UNITED STATES PATENT AND TRADEMARK OFFICE

APPLICATION NO.	FILING DATE	FIRST NAMED INVENTOR	ATTORNEY DOCKET NO.	CONFIRMATION NO.
10/804,900	03/19/2004	J. Kenneth Burkus	4002-3501/PC361.18	8205

Office Action Summary

FIG. 3

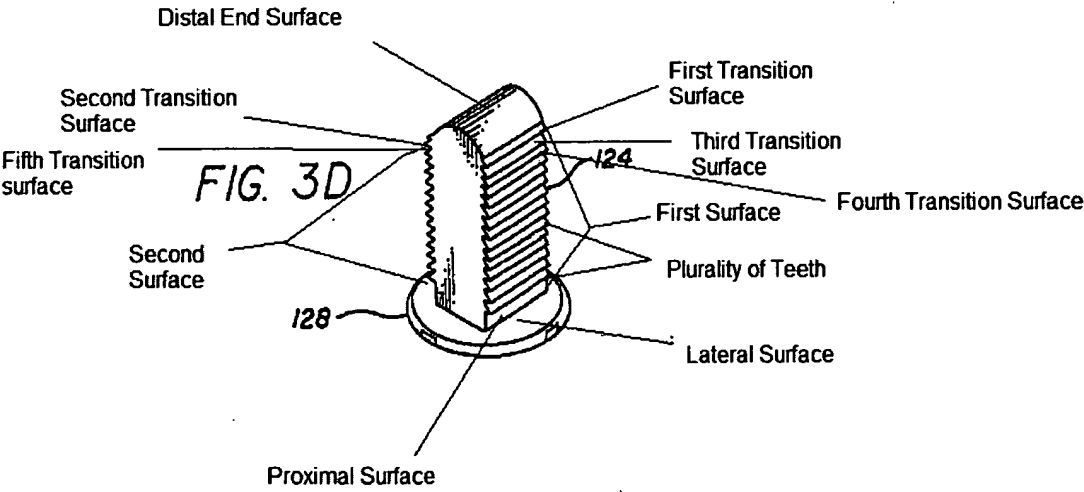
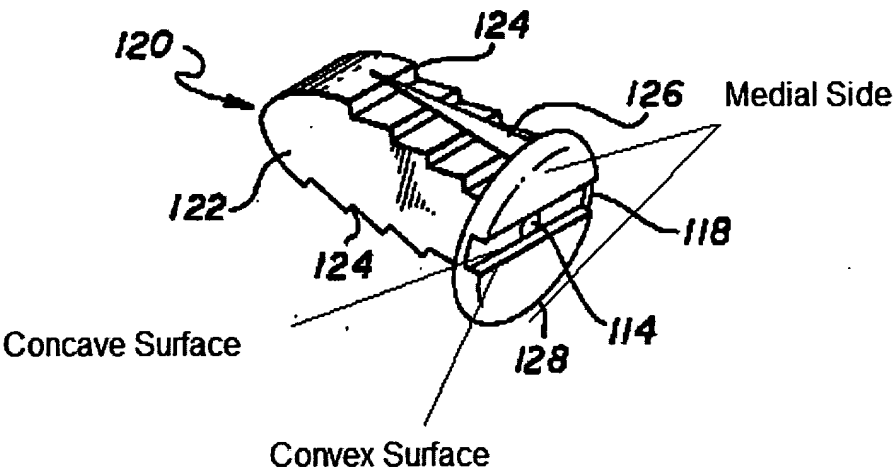
area extending along a medial side thereof (Fig. 3, below). The recessed area is a concave surface (Fig. 3, below). The first distractor includes a convex surface along said medial side thereof (Fig. 3, below), and said second distractor includes a convex surface along said medial side thereof (Fig. 3, below). A distal end of said guide sleeve includes a pair of opposite flanges (342, Fig. 7D) extending distally therefrom. The working channel includes a first working channel portion for receiving said first distractor and a second working channel portion for receiving said second distractor (340, Fig 7c). The first working channel portion and the second working channel portion form a figure eight shape (340, Fig 7c). The guide sleeve includes a sleeve cap (344, Fig. 7F) at said proximal end of said guide sleeve, said sleeve cap including a proximal end ring (344, Fig. 7F) engageable to said distractor driver cap.

The at least one of said first and second distractor tips includes: a lateral surface (Fig. 3D, below) opposite the other of said first and second distractor tips when positioned therealong; and a third transition (Fig. 3D, below) surface extending between said distal end surface and said lateral surface, said third transition surface having a second curvature (Fig. 3D, below) generally corresponding to a curvature of the inner

portion of the cortical rim of vertebral endplates in an axial plane; a fourth transition surface (Fig. 3D, below) extending between said lateral surface and said second surface, said third and fourth transition surfaces each having a second curvature (Fig. 3D, below). The distal end surface of said at least one of said first and second distractors is linear and orthogonal to a central longitudinal axis of said at least one distractor (Fig. 2). The first and second surfaces of said at least one distractor tip each include a plurality of teeth formed therein (Fig. 3D, below).

The at least one of said first and second distractors said first surface includes a proximal portion (closer to the lateral surface in Fig. 3D) a distal portion (closer to the distal end portion in Fig. 3D) and said second surface includes a proximal portion (closer to the lateral surface in Fig. 3D) and a distal portion (closer to the distal end portion in Fig. 3D), said proximal portions being generally parallel with one another and said distal portions tapering toward one another from said proximal portions toward said distal end surface. The proximal portions are parallel and the distal portions taper towards one another (122, Fig. 3A).
